Porirua's Proposed District Plan 2020

Submission on Porirua's Proposed District Plan

Submission Reference Number #59

INF-Figure 5 Clear visibility splays for pedestrian safety

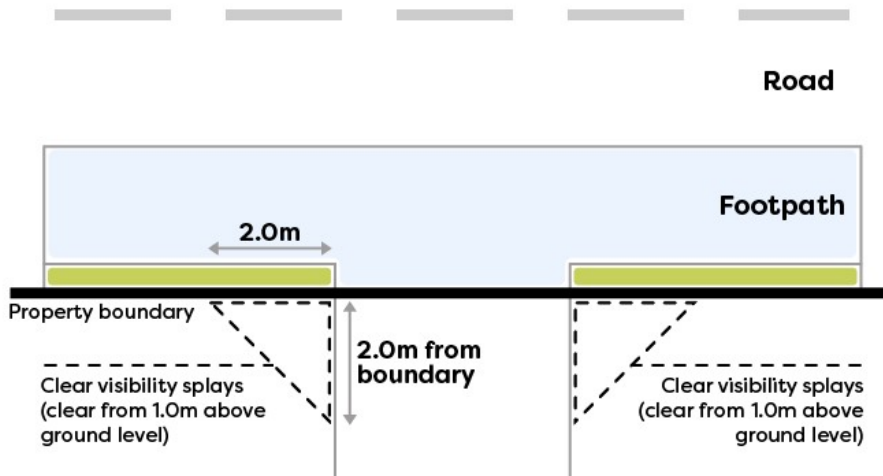
Change word in figure from "Boundary" to "Footpath" and amend the arrow in the diag. to match.
